Cottam Solar Project

Figure 8.16.6: Landscape and Ecology Mitigation and Enhancement Plan – Cottam 1 West (Sheet 1) Revision A

Document reference: EX1/C6.4.8.16.6_A

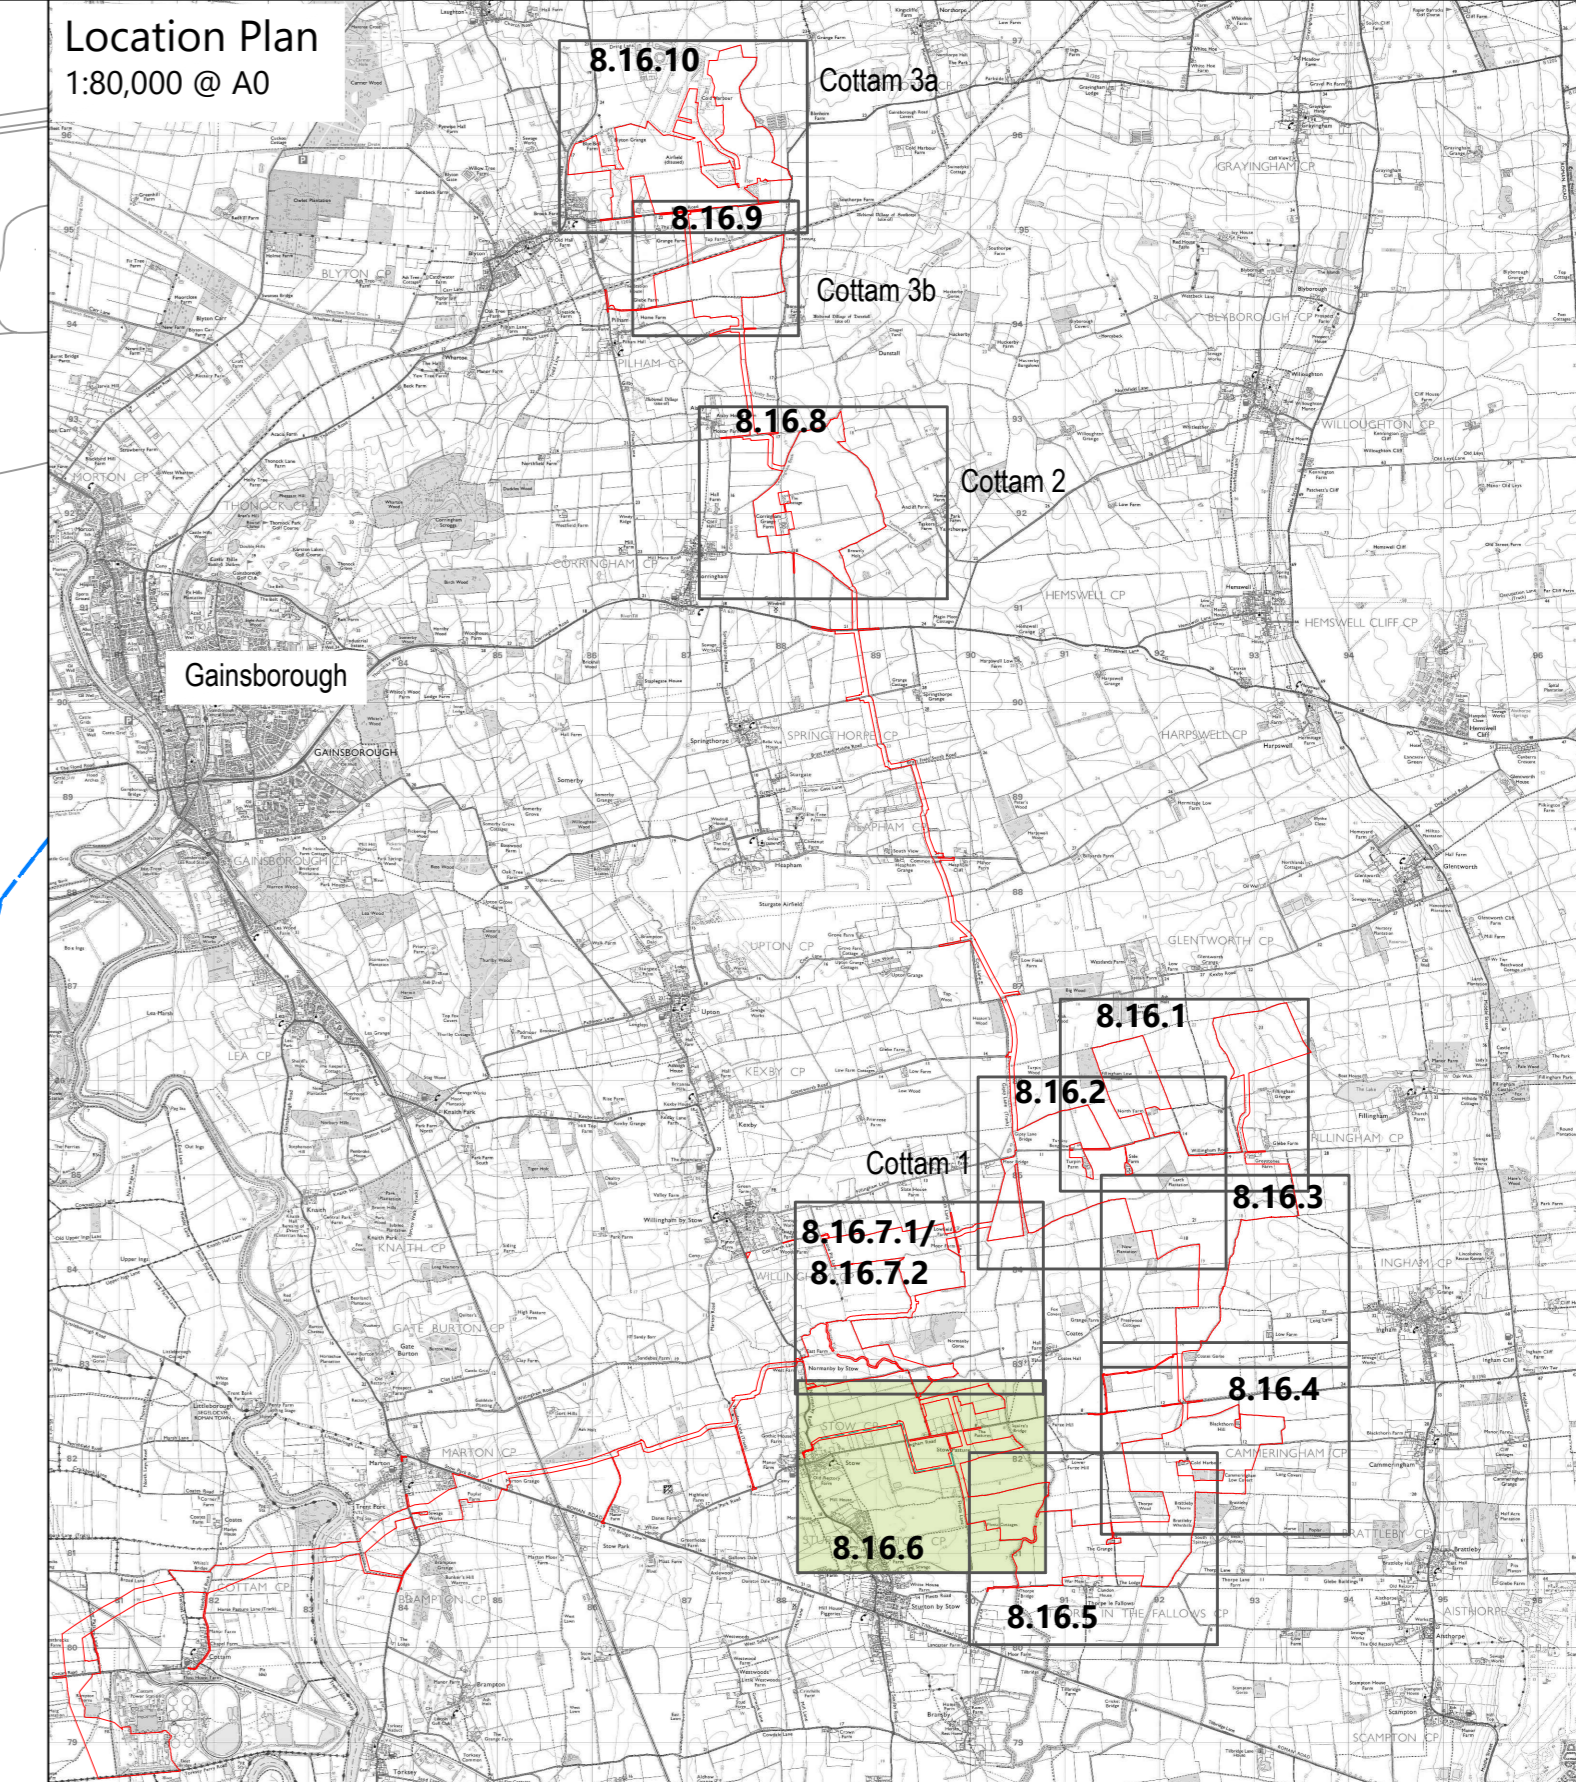
Figure Reference	Page	Description of Changes	Reason for Revision
Figure 8.16.6	3	Change to spelling of 'enhancement'. Offset calculations from drains. Additional Hedgerows to be removed.	For clarity and consistency. To correct a typo.
